From: Robinson, Kelly [mailto:Kelly.Robinson@wnr.com]
Sent: Tuesday, March 29, 2011 2:08 PM
To: Monzeglio, Hope, NMENV
Cc: Schmaltz, Randy; Krakow, Bob
Subject: Bloomfield Refinery River Terrace Discharge Piping Modification Proposal

River Terrace Dewatering Modification

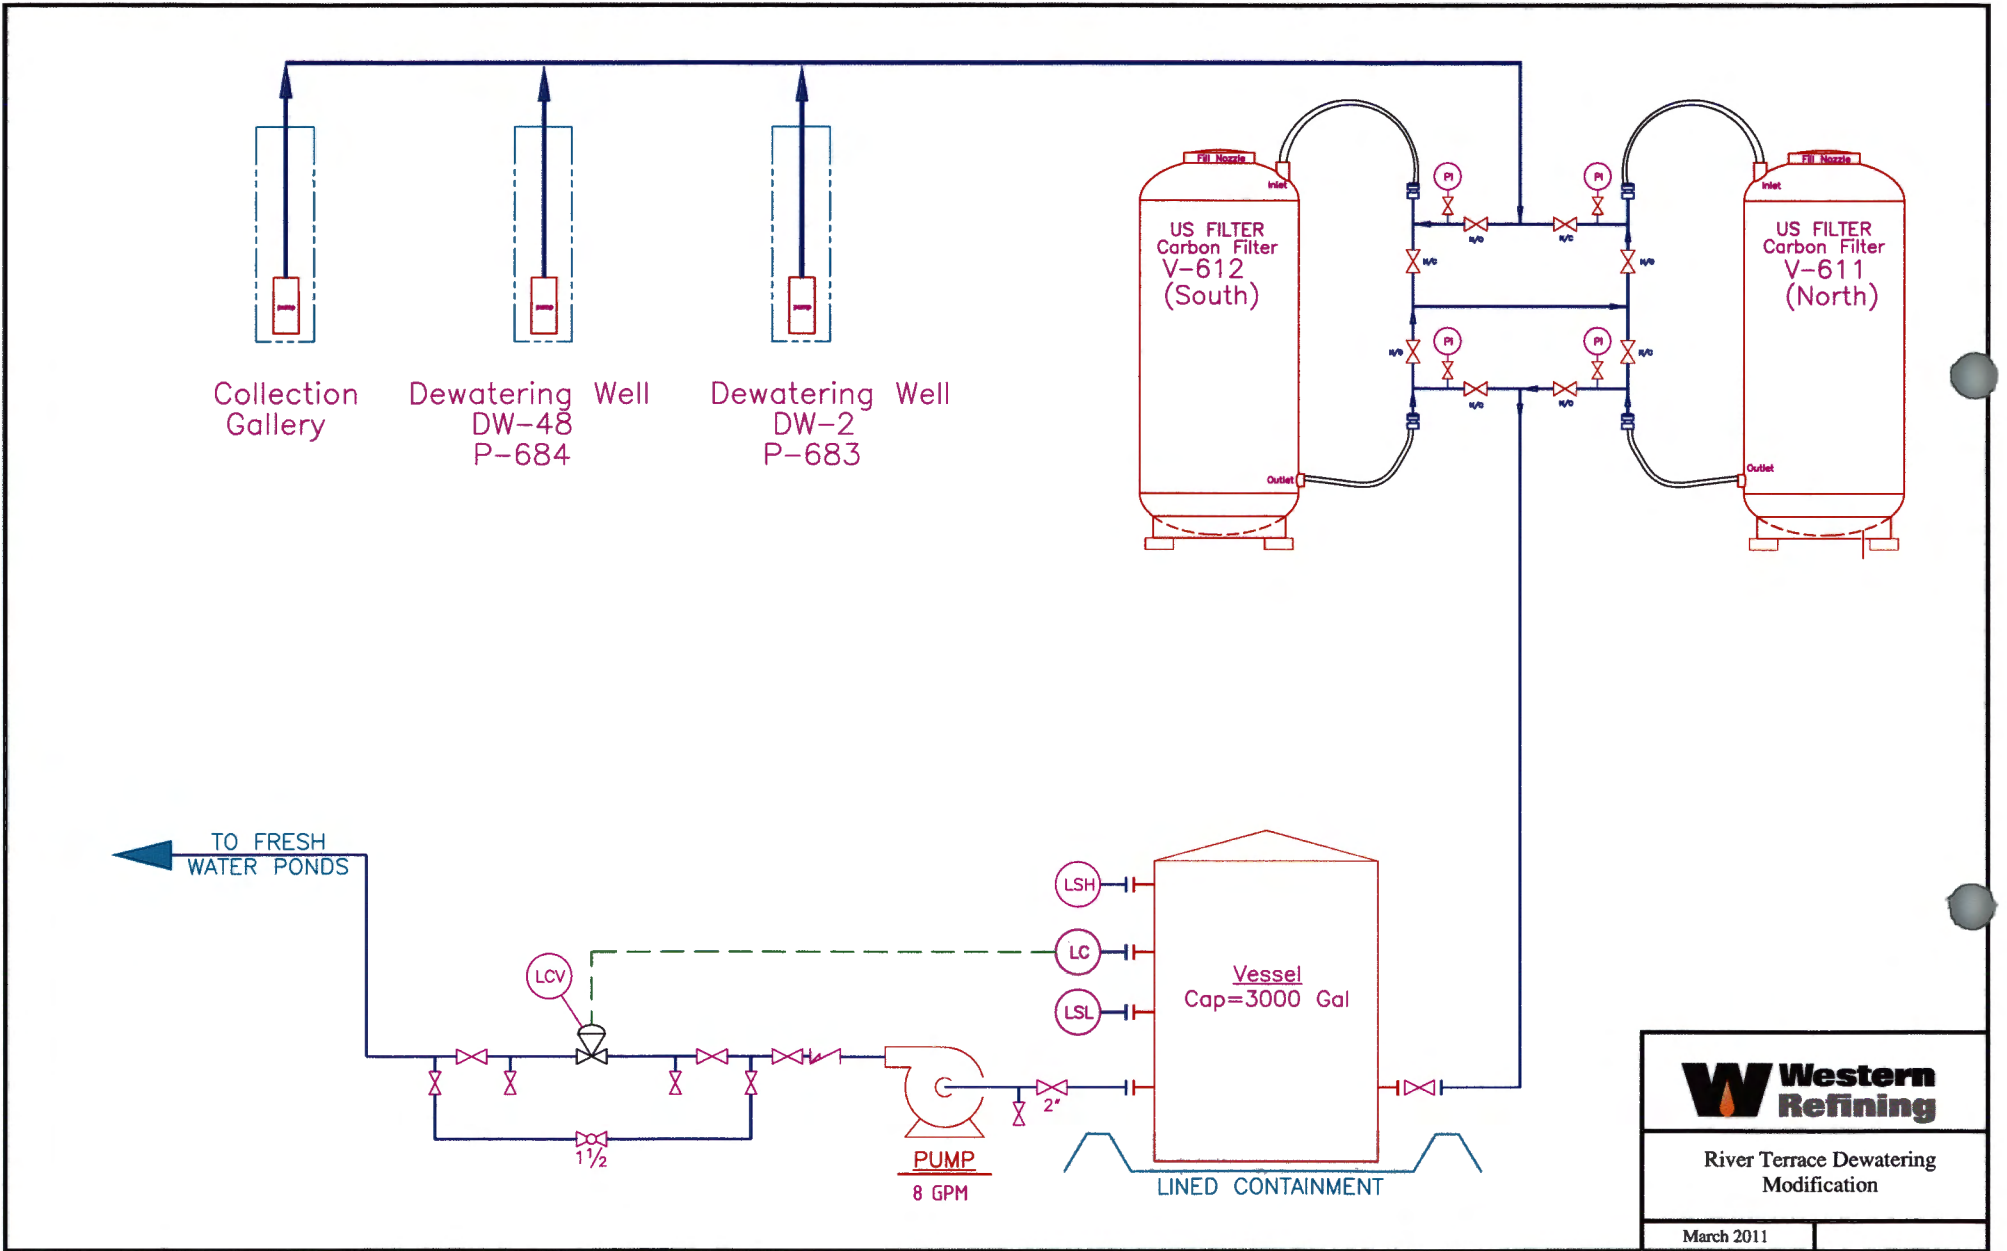
The changes being proposed by Western involves routing the treated river water directly to a 3,000 gallon surge tank. The surge tank will be equipped with a booster pump that will run off level controls. The booster pump will pull the treated river water from that surge tank and discharge into the Refinery fresh water ponds.

This change in configuration will eliminate the current discharge of treated river water into the River Station wet-well, and thus will eliminate the need for operation interlocks between the river terrace dewatering pumps and the Refinery river station pumps. The sampling frequency at the GACs and operation of the GACs in-series will remain unchanged. Attached is a general flow schematic that reflects the proposed changes. As you will see, the proposed changes only affect piping downstream of GAC filters, thus leaving the treatment process at the bioventing system unchanged.

NMED approves the changes discussed below.
